**Meeting:** 5/21/2026  
**Applicant:** Charity Honeycutt  
**Owner:** Charity Honeycutt

**Location:** 1520 Fremont Place **Parcel ID:** 81 L E 045  
**District:** Old North Knoxville H  
**Zoning:** RN-2 (Single-Family Residential Neighborhood)  
**Description:** Folk Victorian with Craftsman and Colonial Revival influences, c.1915

**5-G-26-HZ**  
**APPLICATION FOR CERTIFICATE OF APPROPRIATENESS**

1520 Fremont Place 37917  
 Old North Knoxville H

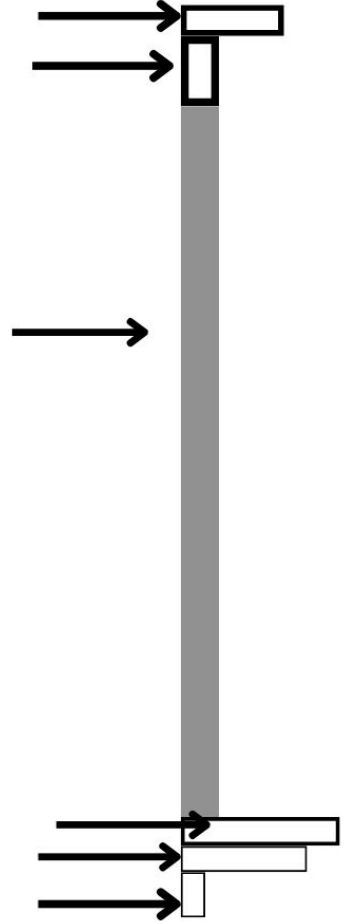
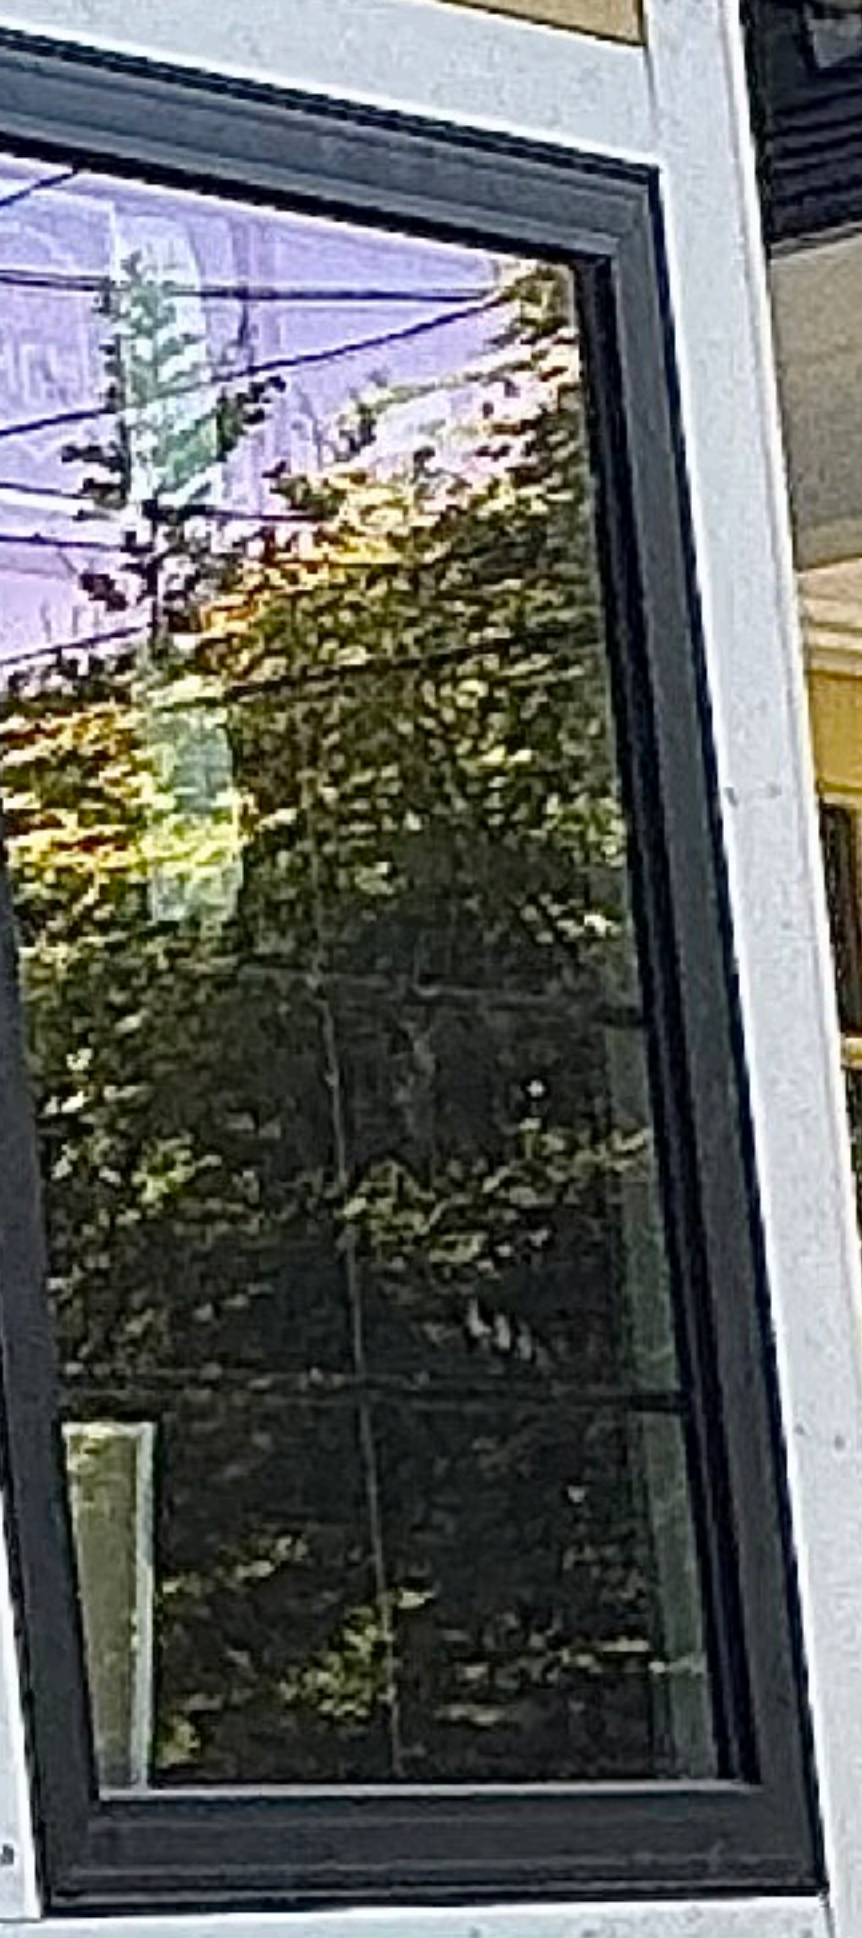
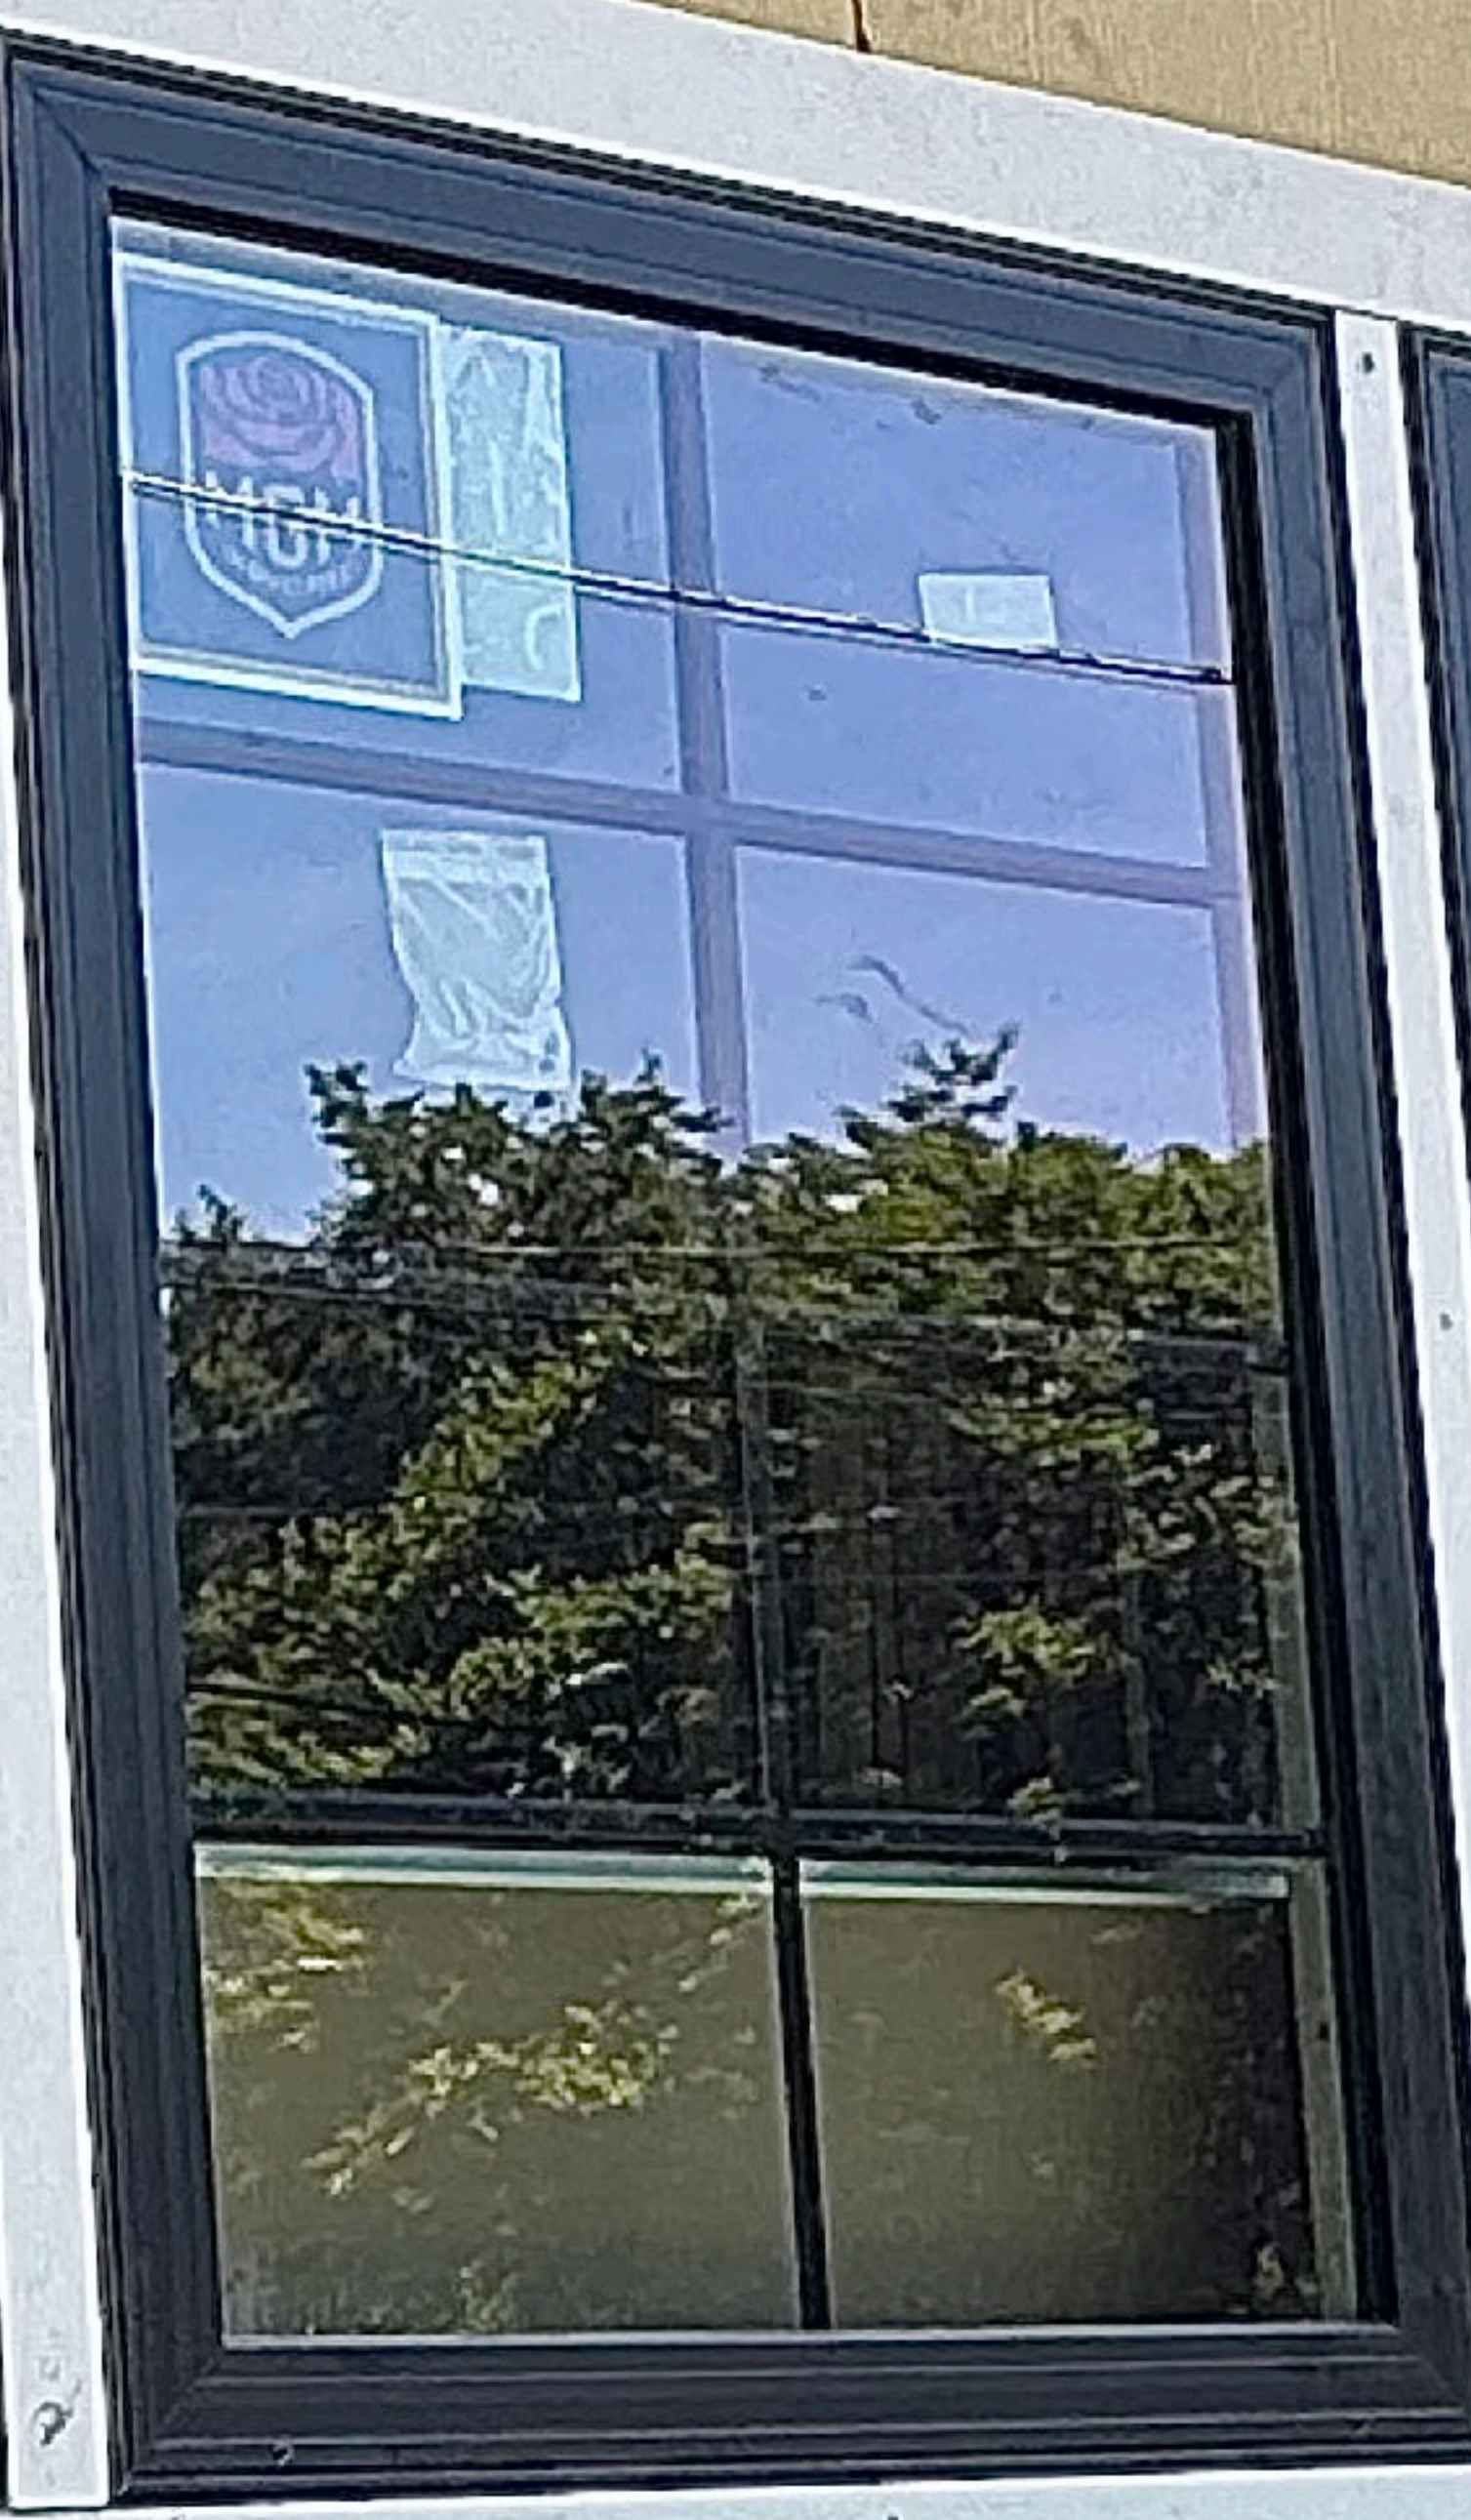
5. The proposed window trim is fiber cement, with a 1x2 header, 1x4 casing, and a 1x6 projecting sill. While proposing fiber cement trim may be appropriate for a house clad in asbestos shingles with fiber cement patching, the trim does not reflect the design of the original trim that was removed. 4" flat casing is wider than the original, and the 1x6 projecting sill will be disproportionate to the windows. A revised specification could include 2" casing, smaller headers, and a smaller sill, and should be submitted to staff for approval. Trim boards should also be applied between adjoining windows to reflect the original trim's depth and dimension.

- 1) pane division on new windows on right side and rear elevation to reflect pane division of original windows;
  - 2) window trim to be revised to better reflect the historic trim's design and size, and trim to be installed between adjoining windows, with final specifications submitted to staff for approval;
  - 3) window trim to be applied to windows on all elevations;
  - 4) revised window schedule to be submitted to staff for approval, showing specific proposed locations of each window.
-
